Intel[®] 82599 10 GbE Controller

Specification Update

July 2024

Revision 4.3
331521-012

Figure 1-2. Package Marketings Prior to PCN 117151

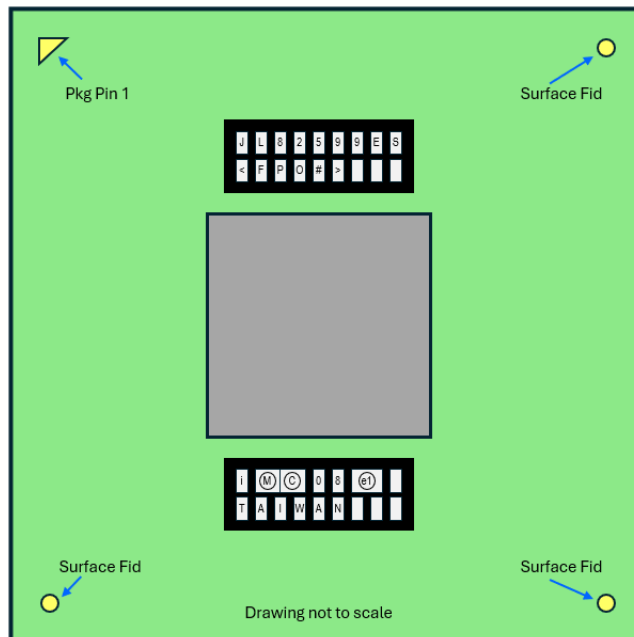
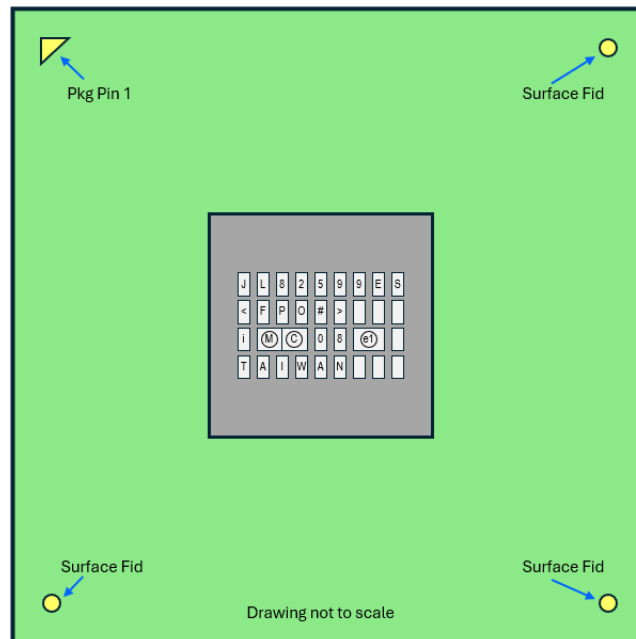
Revision	Date	Comments
4.3	July 3, 2024	Product Code and Device Identification added: <ul style="list-style-type: none"> Figure 1-2 (Added) Figure 1-3 (Added)

Figure 1-3. Package Marketings After PCN 117151
